# Access Compliance Report

## Public Rights-of-Way

### (Curb Ramps)

Intersection ID: 15283	Main Street: BLANDWOOD_DR	Cross Street: CLANTON_RD	Location: S
ADA ID: 087351ABAACB	Ramp Type: PerpDiag	Initial Pass/Fail: Fail	Overall Compliance: No
Severity Score: 21.25			
Codes/Mitigation Info/Possible Solution		Field Measurements/Component Compliance

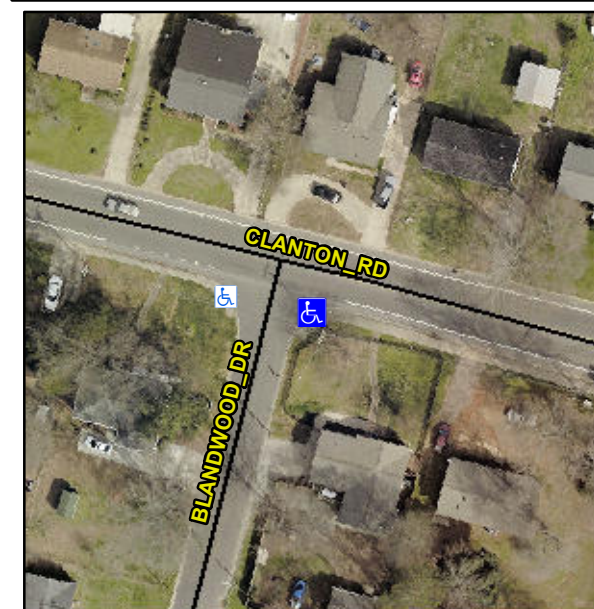
**Not Found, R304.5.1, R304.2.2**

Compliance	Description	Data	Compliance	Description	Data
N/A	Ramp Length (in)	60.0	No	Ramp Slope (%)	10.4
No	Ramp Width (in)	41.0	Yes	Ramp XSlope (%)	1.9
N/A	Flare Type LT	N/A	N/A	Flare Type RT	N/A
N/A	Flare Slope LT (%)	N/A	N/A	Flare Slope RT (%)	N/A
N/A	Flare Traversable LT?	N/A	N/A	Flare Traversable RT?	N/A
N/A	Landing Length (in)	N/A	N/A	DWS Provided?	N/A
N/A	Landing Width (in)	N/A	N/A	DWS Contrast?	N/A
N/A	Landing Slope (%)	N/A	N/A	DWS Length (in)	N/A
N/A	Landing X Slope (%)	N/A	N/A	DWS Full Width?	N/A
N/A	Landing Curb? (Y/N)	N/A	N/A	DWS Offset (in)	N/A
N/A	Shared Landing?	N/A			
N/A	Gutter Ponding?	N/A	N/A	Gutter Slope (%)	N/A
N/A	Gutter Lip Ht (in)	N/A	N/A	Gutter X Slope (%)	N/A
N/A	Painted X Walk1?	No	N/A	Painted X Walk2?	No
	X Walk 1 Direction	To NE		X Walk 2 Direction	To W
N/A	X Walk 1 Width (in)	N/A	N/A	X Walk 2 Width (in)	N/A
	X Walk 1 Slope (%)	3.8		X Walk 2 Slope (%)	2.0
	X Walk 1 X Slope (%)	1.0		X Walk 2 X Slope (%)	3.9

**Remove & Replace Curb Ramp With Two New Directional Ramps or Equivalent.**
